APPLICATION NO.	FILING DATE	FIRST NAMED INVENTOR	ATTORNEY DOCKET NO.	CONFIRMATION NO.
09/936,164	09/10/2001	Takaaki Higashida	2001_1290A	9228

Office Action Summary	Application No.	Applicant(s)	
	09/936,164	HIGASHIDA ET AL.	
	Examiner	Art Unit	
	Jerry A Lorengo	1734

DETAILED ACTION

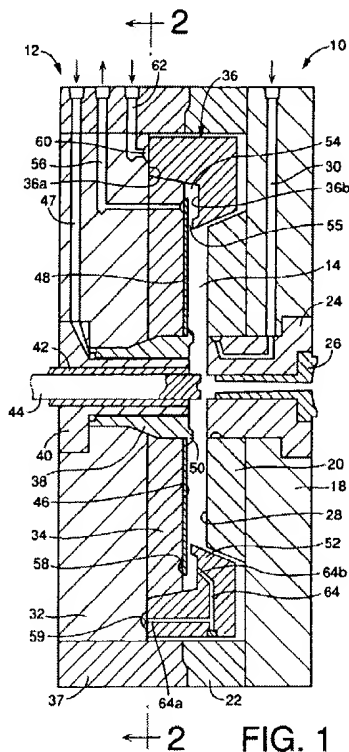
(3) Creating a gap between the stamper 48 held on the surface of the mold half 12 and the molded disc substrate via ejector sleeve 42 and injecting pressurized air supplied via air passage 47 between the stamper 48 and the molded disc substrate to remove the disc substrate from the mold half 12. The method of Asai is more clearly illustrated by the figure shown below:

Although Asai discloses the overall method for removal of the molded disc substrate from the inject mold, he does not specifically disclose, as per applicant claim 36, the move distance to which the molds 10,12 move upon opening. Although Asai discloses the injecting of pressurized air supplied via air passage 47 between the stamper 48 and the molded disc substrate to remove the disc substrate from the mold half 12, he does not specifically disclose the pressure of the air as set forth in applicant claim 37.

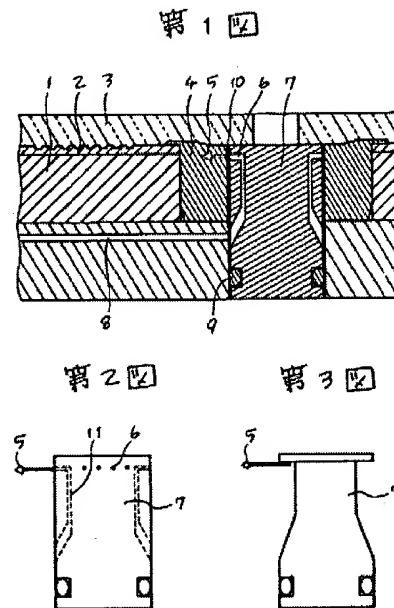
Takada, however, also drawn to optical disc ejecting methods in an optical disc molding process, disclose that after molding, the mold halves are moved apart and an ejector sleeve 7 is advanced and protruded from the mold half 1 which supports the stamper 2 by a distance of 0.1 to 0.3 mm whereupon the molded disc 3 is moved up followed by the injection of air from an air injection port 6 to the gap between the stamper 2 and the molded disc 3 thereby removing the molded sic 3 from the stamper 2 and mold half 1 (abstract; Figures 1-3). The method of Takada is more clearly illustrated by the figures shown below:

Given the teachings of Takada, it would have been obvious to one of ordinary skill in the art at the time of invention to provide the step of opening the mold halves 10,12 of Asai with the move distance set forth in applicant claim 36, motivated by the fact that the skilled artisan would have appreciated that in order to enable the ejector sleeve 42 of Asai to protrude from 0.1 to 0.3 mm from the stamper surface level of the mold half 12 (as suggested by Takada), there must exist at least 0.1 to 0.3 mm of clearance between the mold halves 10,12 upon mold opening from the clamped state. The obviousness of a move distance of 0.3mm or less is further supported by the fact that it is well known in the art that stampers for use in the injection molding of disc substrates (as taught by U.S. Patent Nos. 5,810,941 to Moynagh; 5,376,317 to Maus et al.; or 4,783,041 to Sakaida et al. – all drawn to the formation of optical discs through injection molding)¹ typically have a thickness of about 0.3 mm.
